Groundwater Application Review Summary Form

Application # G- 18890 – REREVIEW #2

GW Reviewer Michael Thoma Date Review Completed: March 18, 2021

TO: Water Rights Section Date March 18, 2021
 FROM: Groundwater Section Michael Thoma
Reviewer's Name
 SUBJECT: Application G- 18890 – RR #2 Supersedes review of January 15, 2021
Date of Review(s)

Analytical Model for Stream Depletion of Tygh Creek

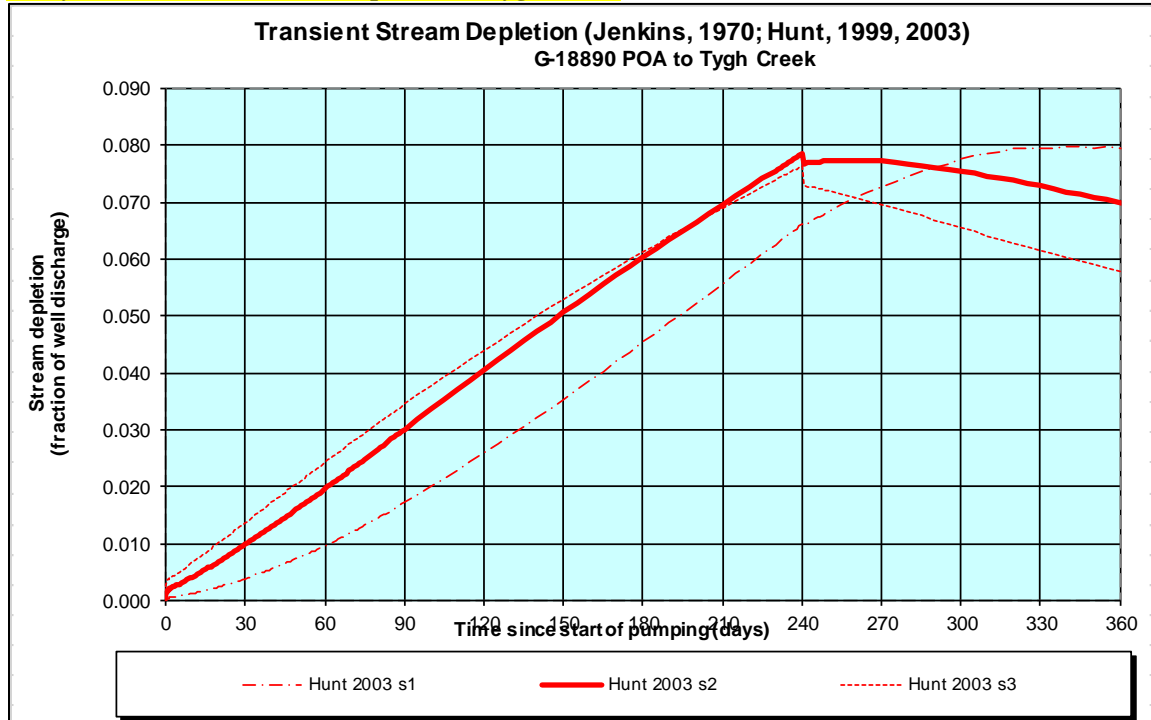
Comments: Interference at 30 days between the well and the surface water sources was estimated using the Hunt 2003 model. The low permeability layers below the stream bed result in an inefficient connection between the aquifer and the stream, therefore interference at 30 days should be less than 25%.
